Northern Beaches Council
Attention: Mr Daniel Milliken
(submitted online at the NSW Planning Portal at <https://www.planningportal.nsw.gov.au/>)

5 January 2023

Response to Request for Information on Survey and Mean High Water Mark Matters for Mod2022/0322, Relating to Construction of Upgraded Coastal Protection Works at 1114 Pittwater Road Collaroy (Flight Deck)

Figure 1: Tidal planes in Sydney from *NSW Tide Charts 2023*

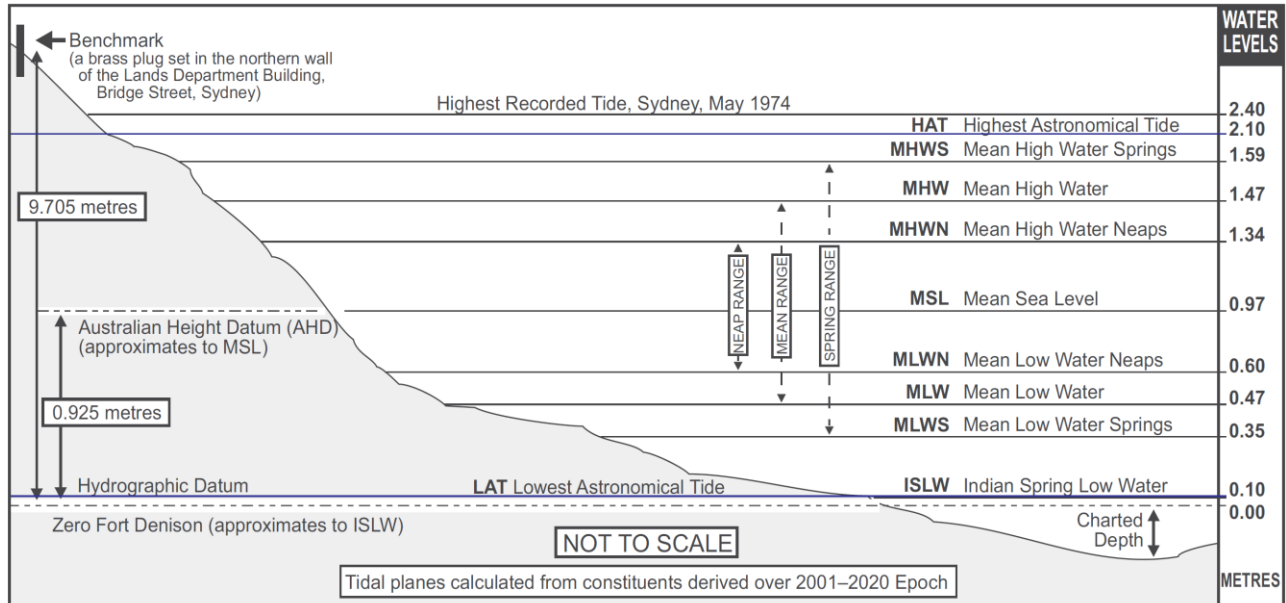
2. All Surveys are to show relevant boundaries in accordance with Part 2 of the *Surveying and Spatial Information Regulation 2017* and identify each of, the existing mean high water mark, the original mean high water mark and any former mean high water mark by reference to bearings and distances from the boundary. Note: If there is a difference between the existing mean high water mark and any former mean high water mark, Council will rely on the most westerly of those lines, so as to ensure proposed works are constructed wholly within privately owned land.

The MHW as defined in the *Surveying and Spatial Information Regulation 2017* is represented by the intersection of the MHW water level in Figure 1 with adjacent land, which is between MHWS and MHWN as per that definition. In Figure 1, MHW is equal to 1.47m relative to Chart Datum. To express this relative to Australian Height Datum (AHD), it is necessary to subtract 0.925m, as depicted in Figure 1. Therefore, MHW is equal to 0.55m AHD at present based on the *NSW Tide Charts 2023*, which can be considered as a reliable and up-to-date source of this information.

Figure 2: MHW positions at and seaward of Flight Deck from 1941 to 2022

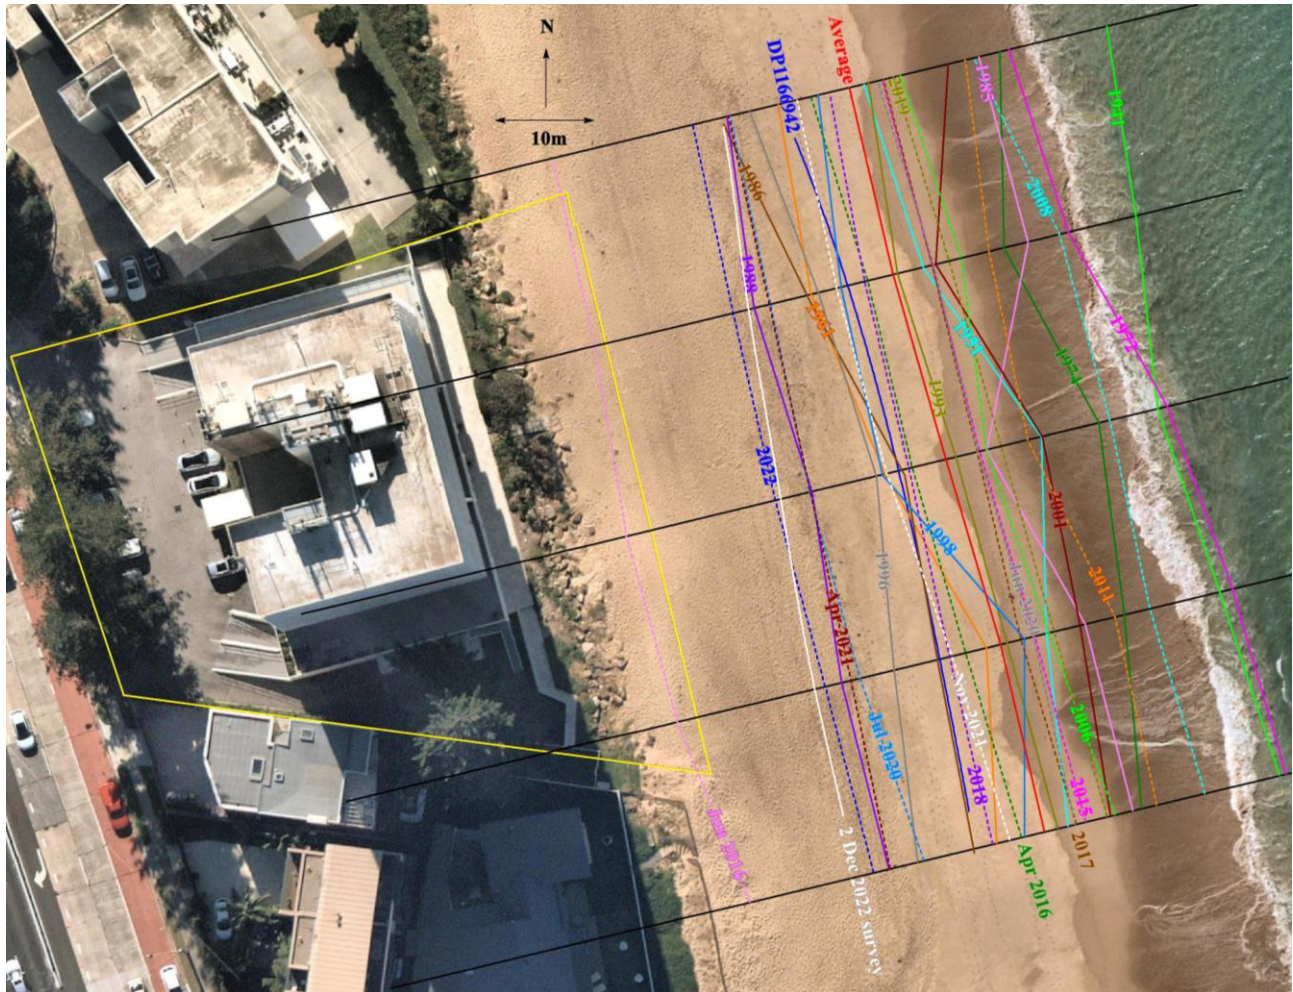
3. The survey is to be accompanied by a Report from the Surveyor which certifies that the survey has been prepared in accordance with Part 2 of the *Surveying and Spatial Information Regulation 2017* and if there is a new mean high water mark shown in the survey document, the reasons for the change.

The average MHW determined from the 26 NSW Beach Profile Database MHW positions is depicted in red in Figure 2. This average MHW is located about 31m to 32m seaward of the subject property, and so happens to be similar to the 1993 MHW.

Hill & Blume (registered surveyor Paul Anthony Cechellero) has investigated available historical MHWs, and found a single MHW defined as part of DP1166942. This DP was registered in 2011, but the details of when the MHW was determined are unknown, and it can be noted that no fieldwork was undertaken to prepare the DP. This DP1166942 position is also depicted in Figure 2. This surveyor also captured the MHW on the date of the survey on 2 December 2022, as depicted in Figure 2.

It can thus be confidently asserted that the long-term average MHW in the vicinity of Flight Deck is located well seaward of the property, in the order of 30m.

It is evident from Figure 2 that the two boundary surveys are essentially indistinguishable. The distance between the NE corner of the boundary in the two surveys is 8mm, and it is a 15mm difference at the SE corner. The 2022 seaward boundary is located about 7mm seaward of the 2017 boundary. In Appendix B, it is noted that the boundaries in the 2022 survey have been defined as accurately as possible, so can be considered to be exact boundaries.

In Appendix B, the surveyor has confirmed that the survey has been prepared in accordance with Part 2 of the *Surveying and Spatial Information Regulation 2017*. The MHWMs depicted in the survey and as derived from the NSW Beach Profile Database do not alter the current right line boundaries in the Strata title, as the long-term average MHW is in the order of 30m seaward of the property. Neither of the MHWMs depicted on the survey are considered to represent the long-term average MHW, with this represented by the red line in Figure 2.
